MONTGOMERY COUNTY HISTORIC PRESERVATION COMMISSION
STAFF REPORT

Address:	9 Primrose Street, Chevy Chase	Meeting Date:	6/11/2025
Resource:	Contributing Resource (Chevy Chase Village Historic District)	Report Date:	6/4/2025
Project Contact:	Alex Smith, Architect	Public Notice:	5/28/2025
Review:	HAWP	Tax Credit:	Partial
Permit Number:	1001603 REVISION	Staff:	Dan Bruechert
PROPOSAL: Dormer and fenestration alterations and porch alterations

Porch Flooring

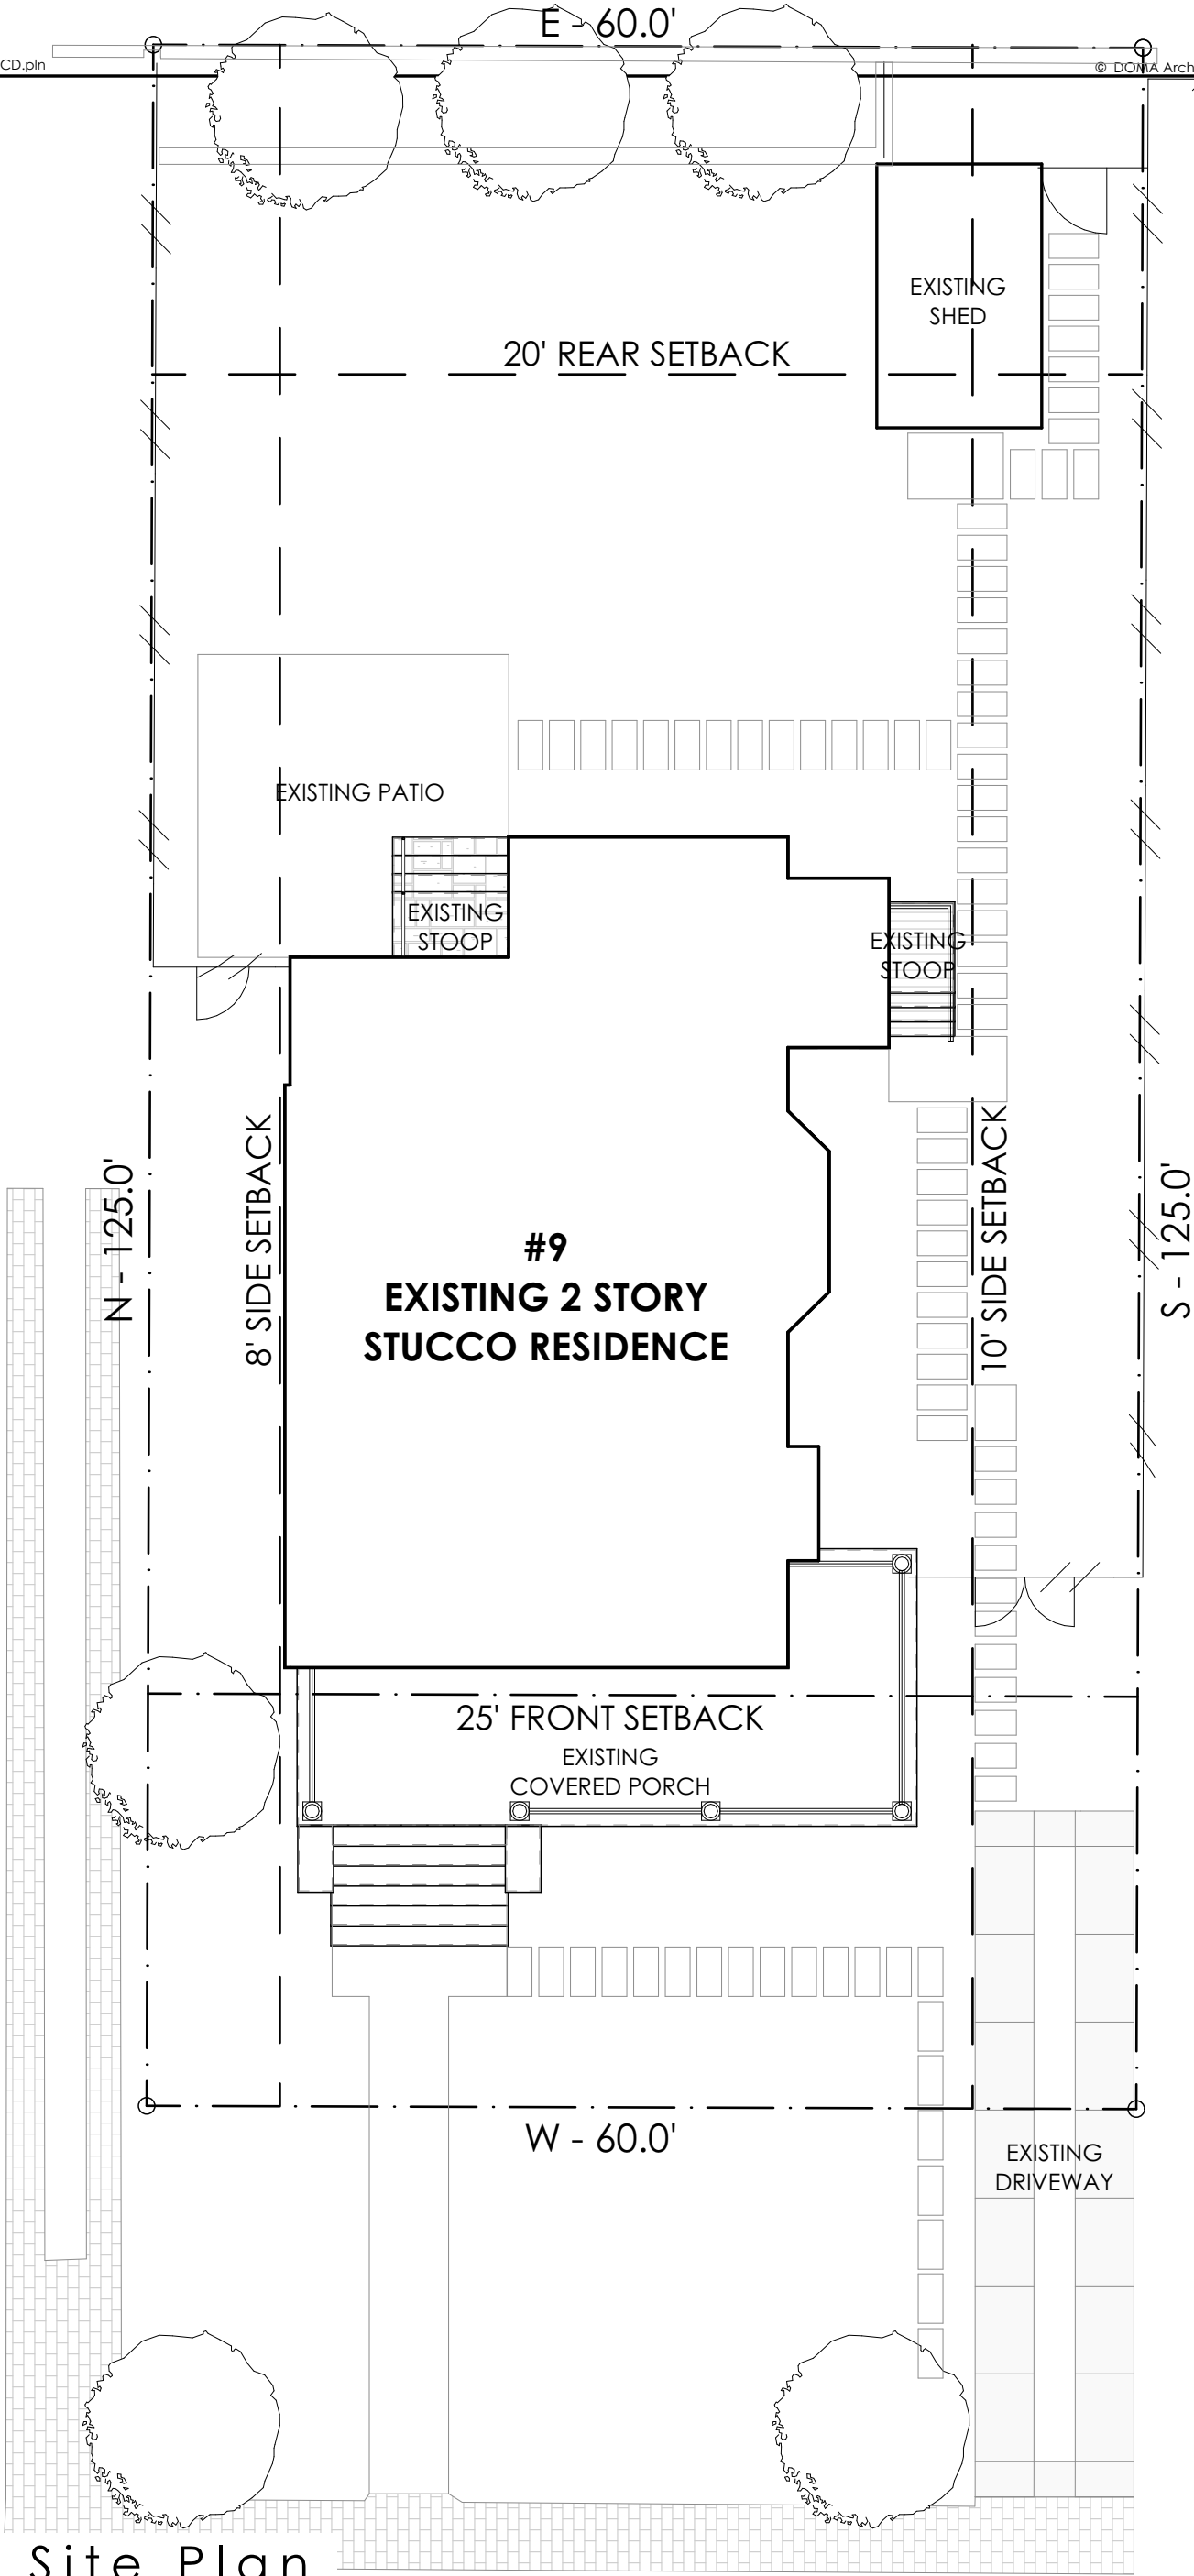
The existing front porch has wood tongue and groove flooring with flagstone stairs. The applicant proposes to remove the existing porch flooring and replace it with Aeratis Heritage, a PVC product, in tongue and groove flooring. No work is proposed for the stairs. The existing porch floorboards have warped and cupped in spite of the applicant’s maintenance. This material degradation is likely due to UV damage exacerbated by the house’s south facing orientation.

The proposed floorboards are 3” (three inches) wide and have hidden fasteners. The proposed material will come with a gray finish, however, the material can be painted or stained. At the intersection of the front porch and the house, the applicant proposes to install a quarter-round trim piece, matching the appearance of the floorboards. All board will be installed perpendicular to the front wall plane.

Staff finds the existing porch flooring is likely not the original porch and that the material integrity has been compromised and recommends the HPC approve its removal under 24A-8(b)(2).

texture. The specifications provided in the application show the half-round trim piece that will be installed over the exposed tongue and into the edge groove. However, details do not include the proposed treatment for the board ends. Aeratis manufactures a trim piece called a ‘chamfer nosing’ that covers the cut ends of the boards. Staff recommends the HPC include a condition for the approval of this HAWP revision that the applicant is required to install the chamfer nosing at the front edge of the porch and require the applicant to submit plans showing this treatment to Staff to verify before issuing the approval documents. With that condition, Staff finds the proposed front porch treatment is consistent with 24A8(b)(2) and (d); Standards #2, 6, and 9; the *Design Guidelines*; and Historic Preservation Commission - Policy No. 24-01 ADOPTED POLICY FOR THE APPROPRIATENESS OF SUBSTITUTE MATERIALS FOR PORCH AND DECK FLOORING.

1. The front porch may not leave the board edges exposed and must utilize the "chamfer nosing" trim. Details showing the location of this trim must be submitted before the issuance of the approval documents and
